Seven Capital (Highgate Hill) LBI Highways Response Note

SLR Project No.: 425.065924.00001

Revision: 02

RE: ARCHWAY CAMPUS, HIGHGATE HILL [REF: P2024/2598/FUL]

Figure 2.1: Distances to BB Bays

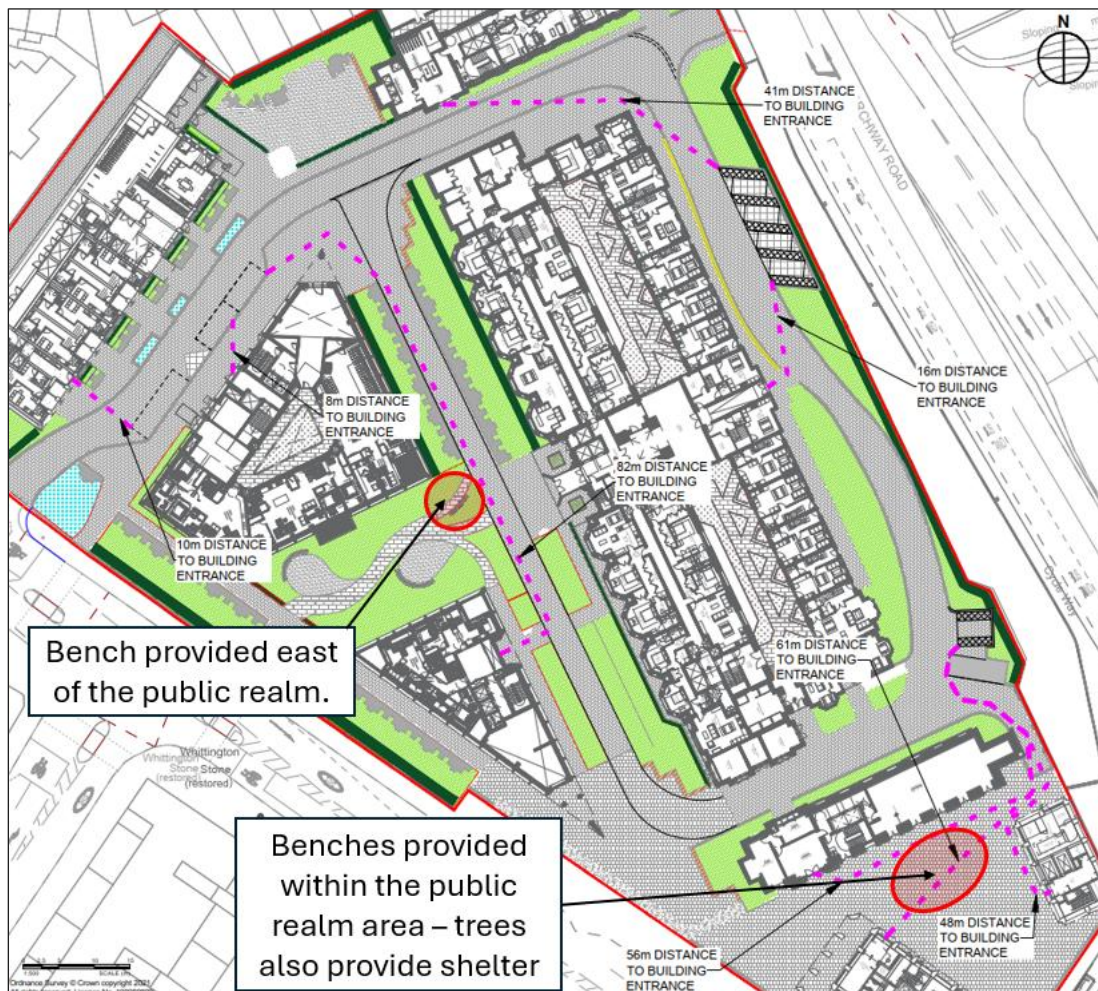
Figure 5.7 within the HSTAA shows the distances between the buildings and Blue Badge spaces. Some of these distances are significantly exceeded. The distance from Block C to a Blue Badge space is 82m and the distance from the Clerkenwell building (56m) and Student building (61m) exceed the minimum 50 metre requirement. If the distances are exceeded, level resting places should be identified and provided. Consideration should be given to reducing these distances by finding space to accommodate another space towards the southern end of the masterplan -see potential area of search on drawing at Appendix A

- 2.20 The above is noted. Regarding resting places, these are proposed to be available in suitable and convenient locations where walking routes exceed 50m. These locations are marked within the plan below and in the proposed landscape plans.

- 2.21 Regarding the provision of a new parking bay to the south of the Site. As shown in Figure 5.6 of the TAA, alternative locations have already been considered. A parking space in the location suggested by Steer would not be possible as this is within the proposed sustainable transport corridor which will have restricted access. A parking space would also then be located within a key area of public realm which has been designed primarily for pedestrian activity and not the presence of cars. Hence, it is not considered appropriate or necessary to provide a parking bay in this location.

Figure 2.2: Car Club Bay Plan 1

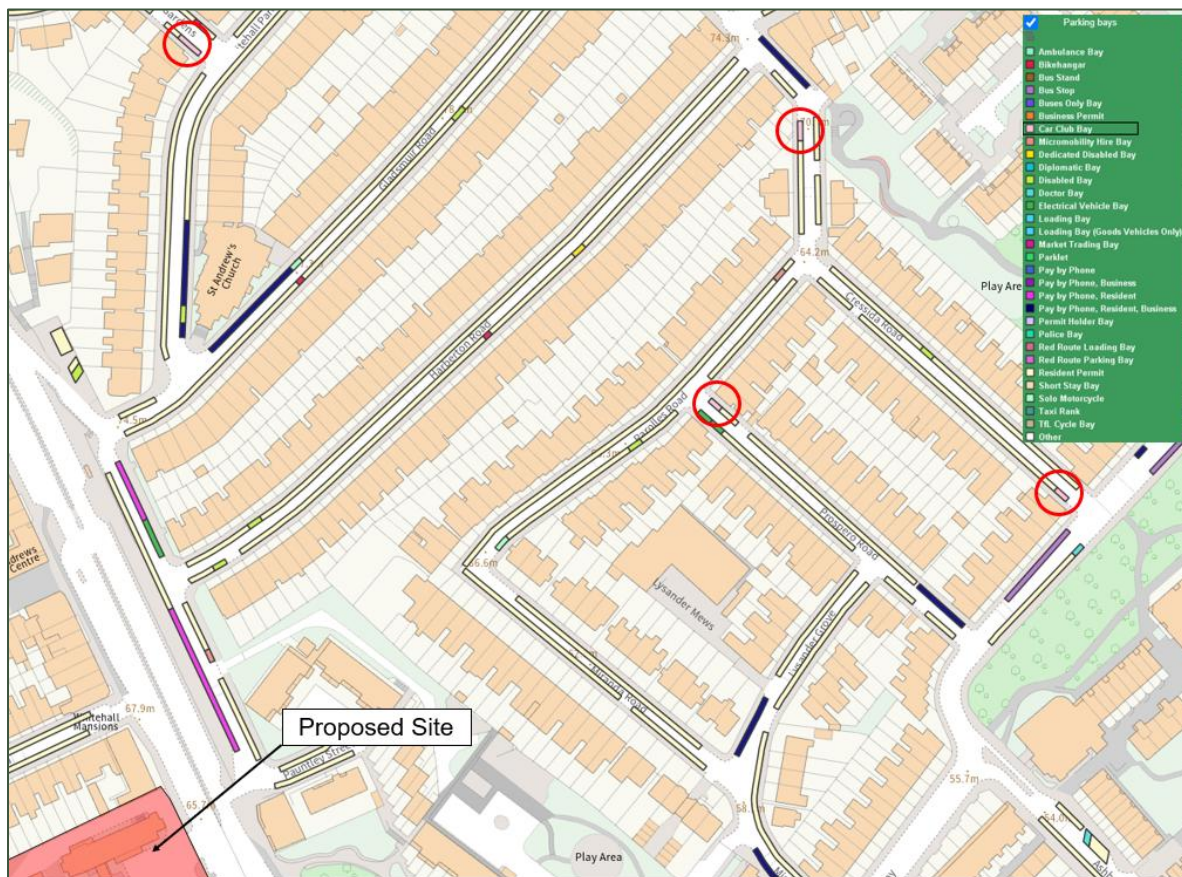
The Outline Car Park Management Plan shows indicative locations as icons on Figure 2.3, however, no context is provided to show whether there is space on the actual streets to accommodate the bays and what facilities might be lost.

- 2.26 A review undertaken by SLR indicates that vacant car club bays are currently available within proximity to the Site. This review identified 6 car club spaces within a 750m walking distance of all buildings across the Site. Therefore, while alternative locations for new bays were previously identified by SLR, the availability of existing vacant bays demonstrates that suitable provision is available. This approach would avoid the need to remove resident parking spaces or implement additional Traffic Management Orders (TMOs).

- 2.27 The location of these vacant bays is shown in **Figure 2.2 and 2.3**. These figures show extracts of the Interactive LBI Map – with the parking layer showing. It should be noted that two plans have been prepared to ensure that enough detail can be shown on the interactive map. All these spaces are within at most a 1km walking distance from the Site.

Appendix A – Area of Search for Additional Blue Badge Space

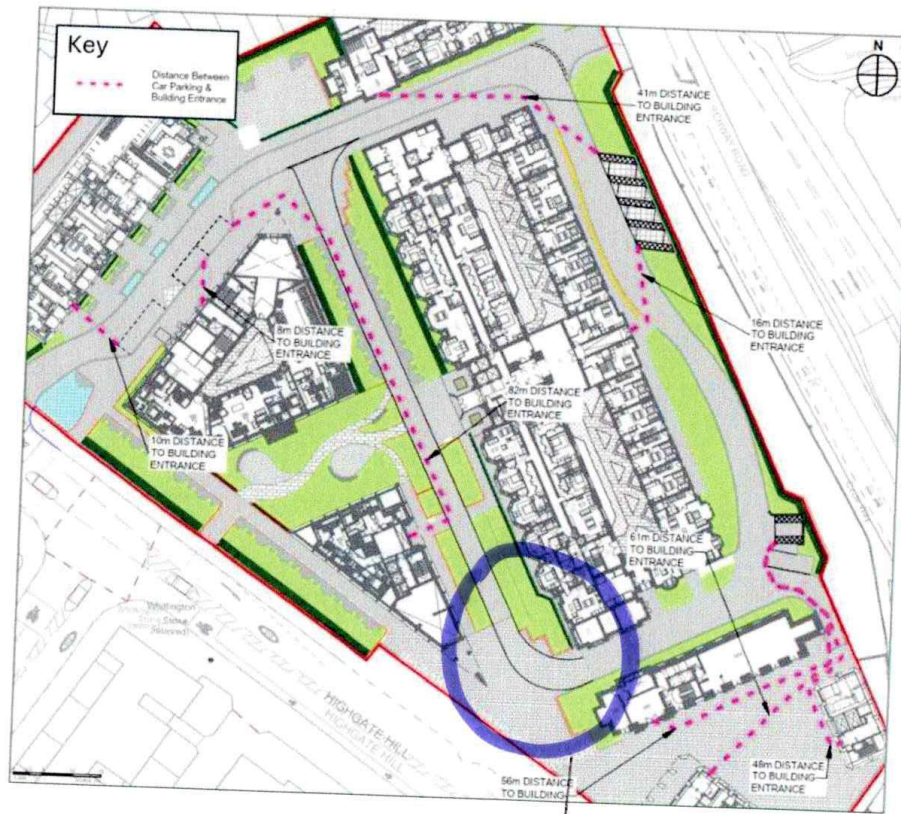
Potential Area of
Search for additional
Blue Badge
parking space

Appendix B – Suggested Enhancements for Cyclists

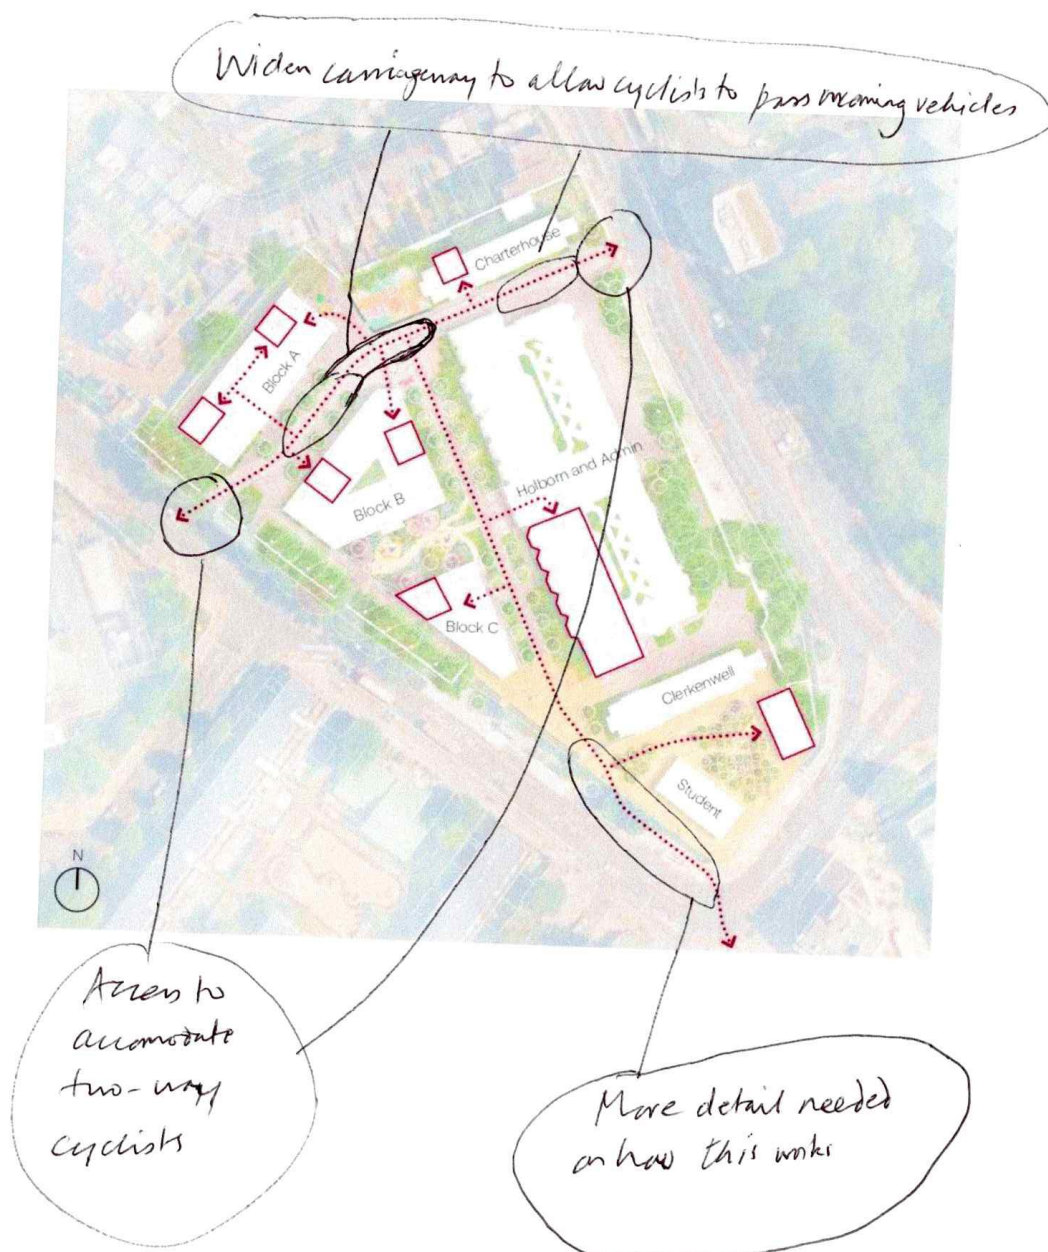
Chapter 5 of the HSTAA still proposes westbound only cycle movement through the site on the northern east-west route through the masterplan between the site access points. A west-east cycling option should also be explored as this will occur, with designs provided to identify how this could be integrated at the site access points with Highgate Hill and Archway Road. This would help ensure that the scheme complies with Local Plan Policy T2 Part E and London Plan Policy T5 – see the markup at Appendix B, which suggests provision of intermittent passing places

The DAS also shows aspirations for a direct connection between the development and the cycle crossing on Highgate Hill towards Navigator Square – see the markup at Appendix B. This is supported by LBI but the Applicant needs to provide a concept drawing showing how this would work in practice.

Suggested further interventions to
assist cyclists — Steer, 27/07/26

- 2.65 The provision of an east-west cycle connection through the Site has been considered previously and is assessed in detail at Paragraphs 5.24 to 5.32 of the TAA, supported by associated routing figures. That assessment demonstrated that a dedicated contraflow cycle route through the Site would deliver limited transport benefits and is therefore not considered necessary.

- 2.77 The routing shown within the DAS provides an illustrative representation of general movement through the Site by cyclists. The more detailed and relevant assessment of cycle movements is provided within the TAA, with the associated cycle routing plans reproduced below.

Appendix E – Construction Routing Plans

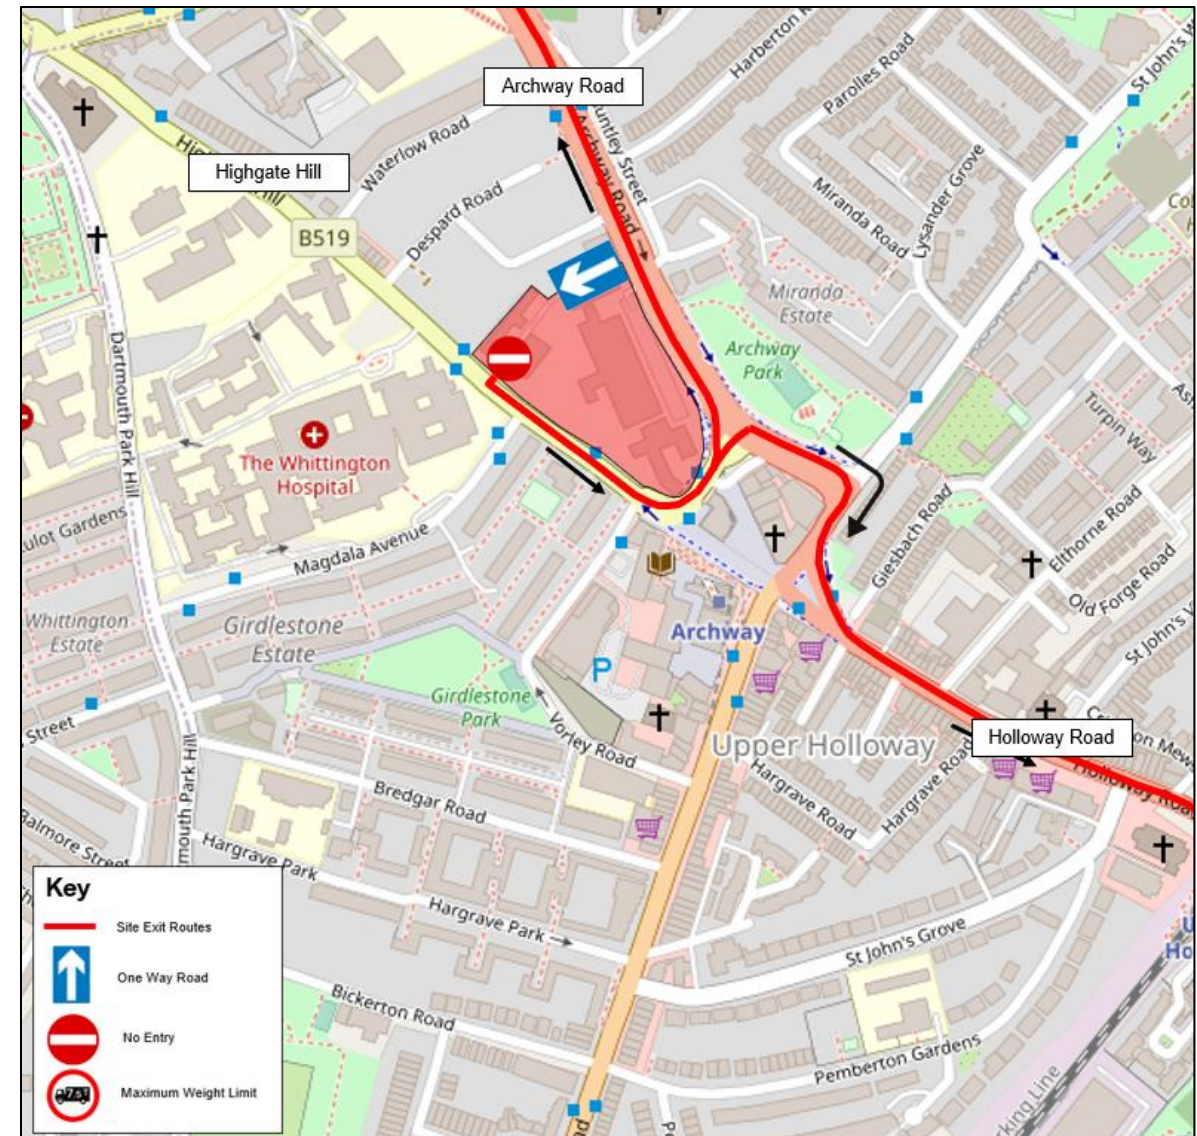
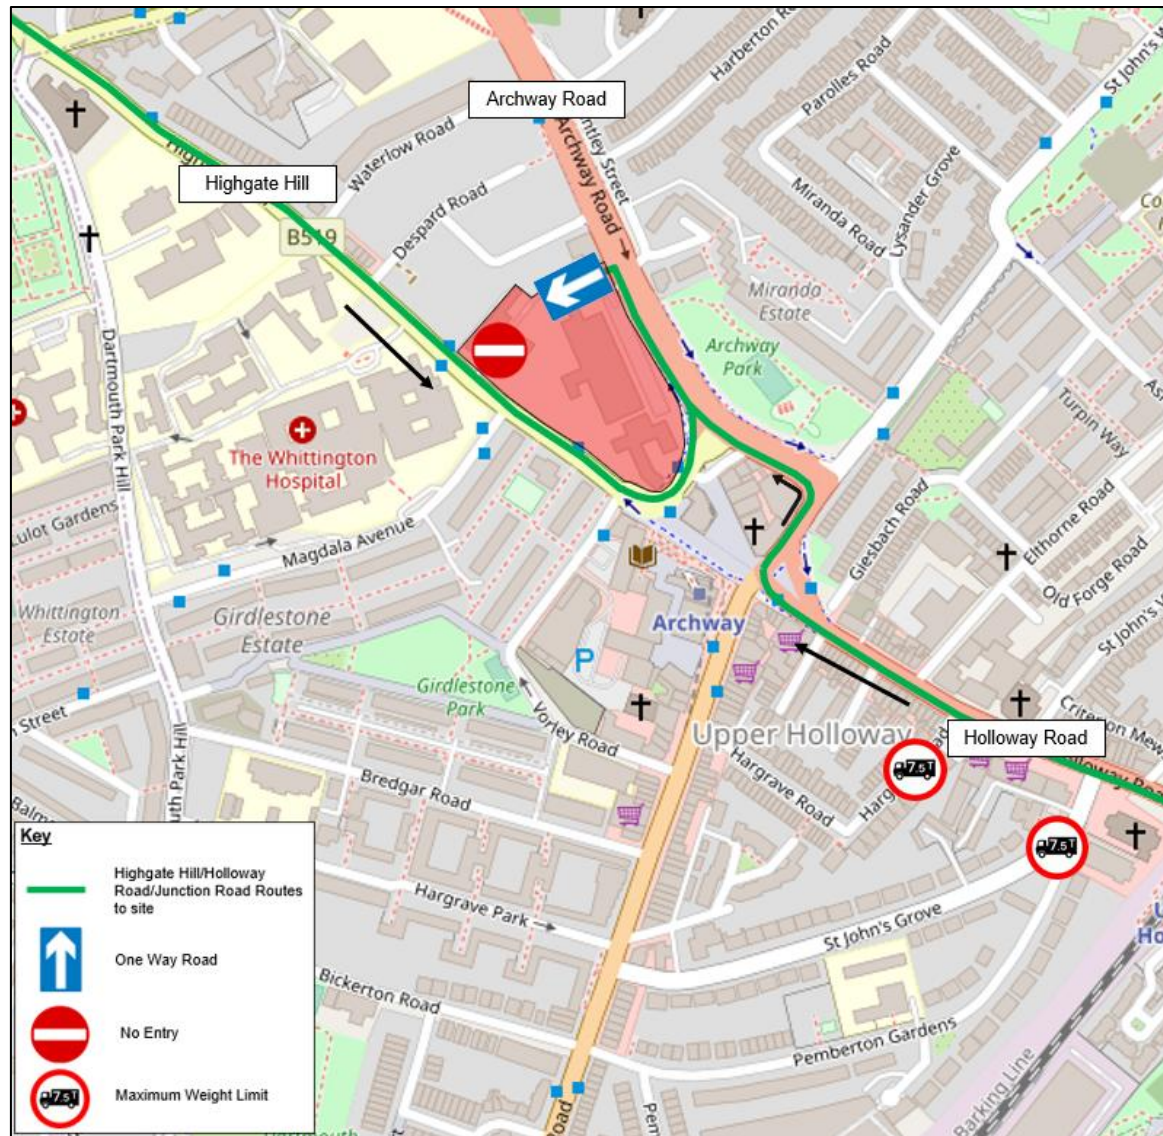
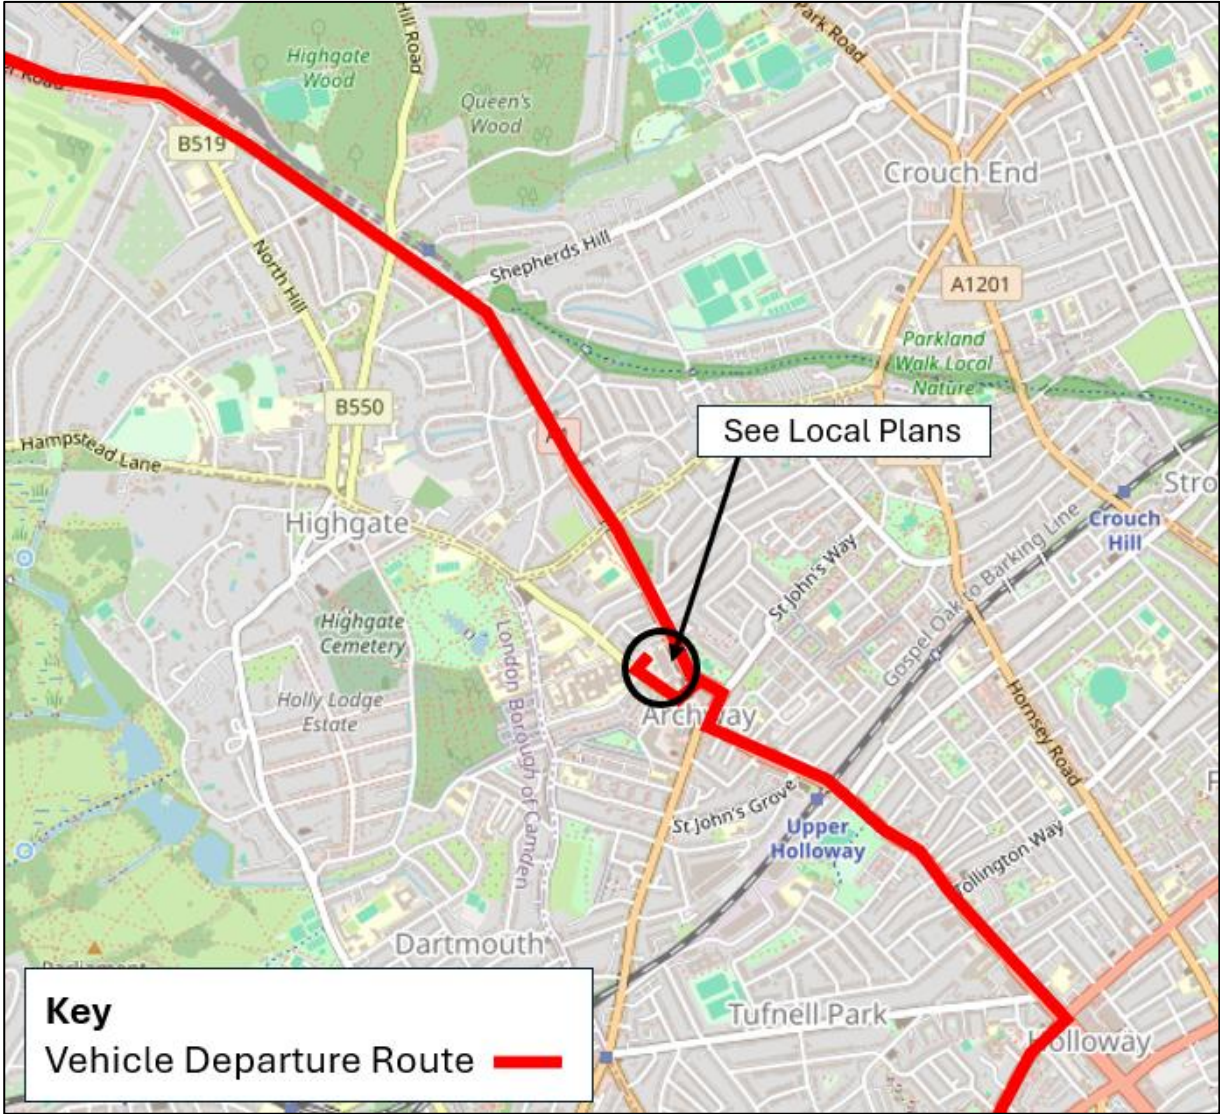
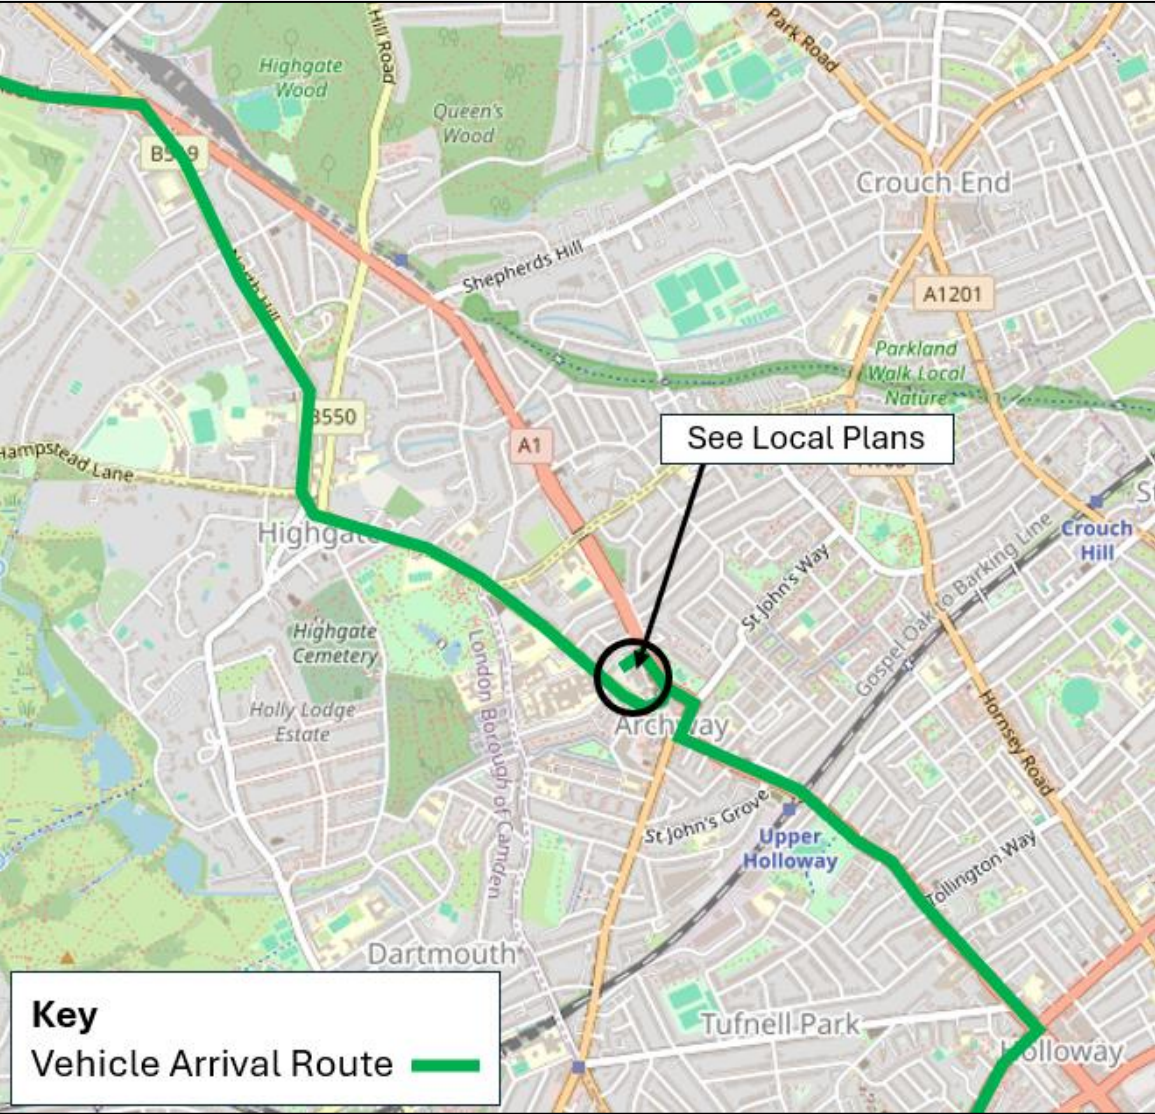
Further consideration should be given to construction vehicle routing with a drawing provided to show the wider vehicle routing extent particularly to the north. There is concern over construction vehicles using Hargrave Road and St John's Road, given the 7.5T weight restrictions on these roads, and the residential nature of these roads, particularly Hargrave Road. The preference would be for construction vehicles to be limited to the A1 Archway Road/ Holloway Road and Highgate Hill south of the site access.

- 2.126 Considering the above, and routing to and from the Site it is considered that it would be appropriate for construction vehicles to be limited to the A1 Archway Road/ Holloway Road and Highgate Hill south of the site access. A routing plan is provided at **Appendix E**.
